REVISION:001

Lot 15 Heritage at Neills Creek

PLAN 5 THE APEX - LH 'CRAFTSMAN'

ARCHITECTURAL DRAWINGS

SHEET
1.1.1c

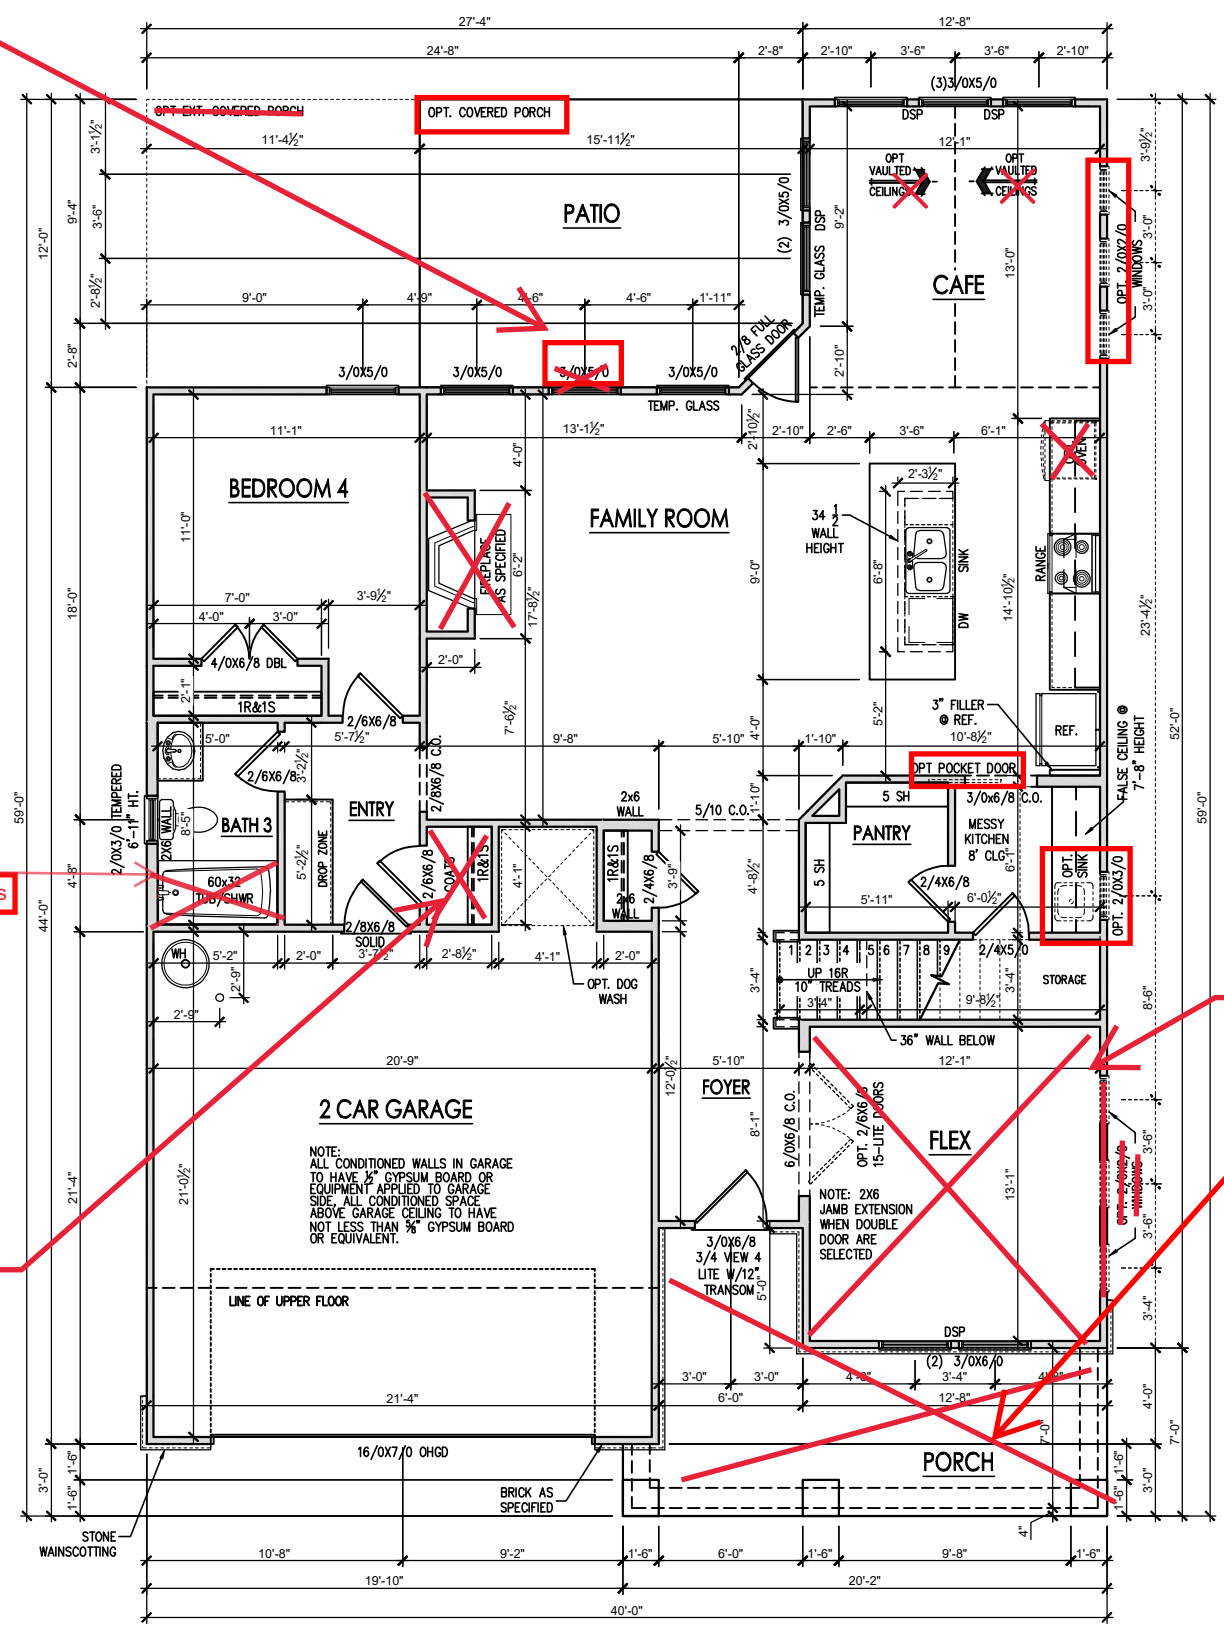
Reduce this Offset to 2'

DRAWN BY: South Designs
ISSUE DATE: 07/01/2021
CURRENT REVISION DATE: -
SCALE: 1/8" = 1'-0"
SHEET 2.1c

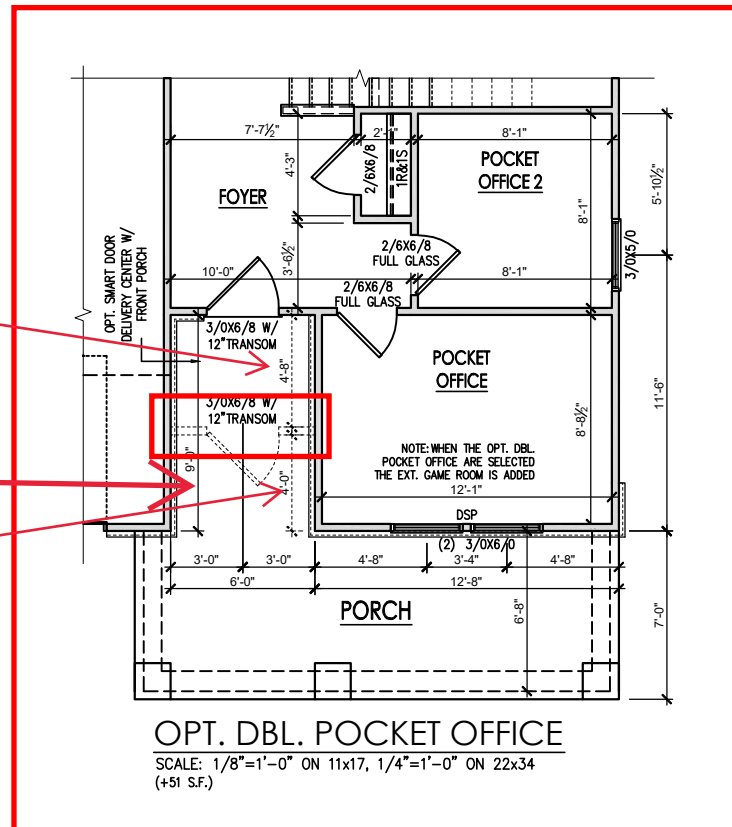
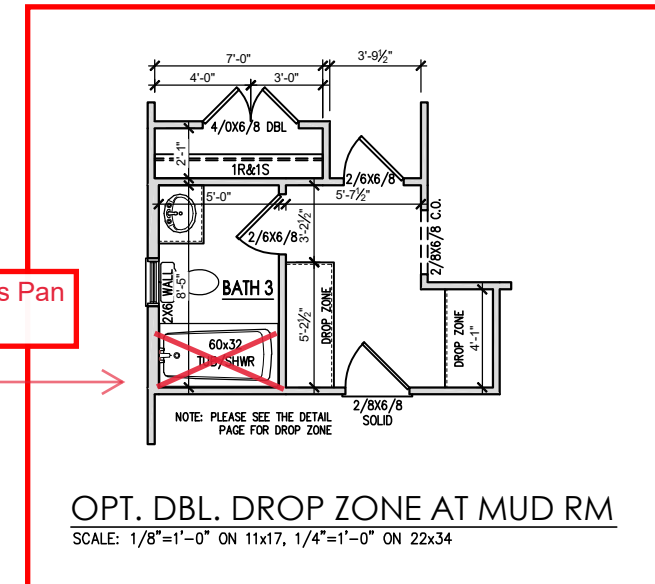
Increase this offset to 6'-8"

Increase Smart Door Delivery depth by 2' & Swing Front door into home - change to LH

Reduce this offset to 2'-0"
